UNITED STATES PATENT AND TRADEMARK OFFICE

Office Action Summary	Application No. 10/783,162	Applicant(s) VINSON ET AL.	
	Examiner Vikansha S. Dwivedi	Art Unit 3746

DETAILED ACTION

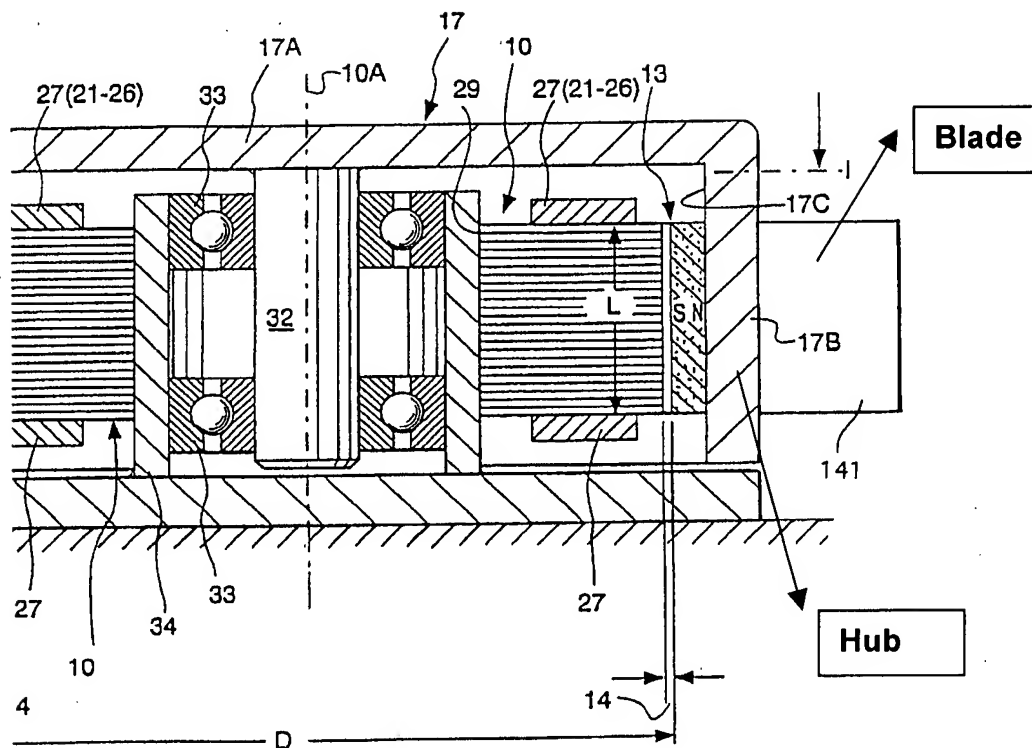
Von der Heide teaches a cooling fan comprising: a three-phase DC motor, an impeller comprising a hub to house said motor and a plurality of blades 141 extending from the hub. It should be clear rotor housing 17 is the hub and has plurality of blades 139 and 141 extending from the hub 17. for applicant's convenience the hub and the Blade are shown below. It is a marked up copy of Von der Heide figure 2.

It should be clear that a impeller is the rotating part that transmits motion in a device such as a cooling fan. In case of Von der Heide a magnetic external rotor comprises an inverted cup-shaped rotor housing/hub 17 with a horizontal top surface 17A and a cylindrical circumferential wall 17B that supports the blades 139 and 141. Stub shaft 32 is attached to the center of rotor housing 17 at the center of top 17A. Stub shaft 32 rides in ball bearing journals 33 and is supported thereby in a manner that rotor housing 17 is pivotally secured to stator 10 and can rotate about center axis 10A.
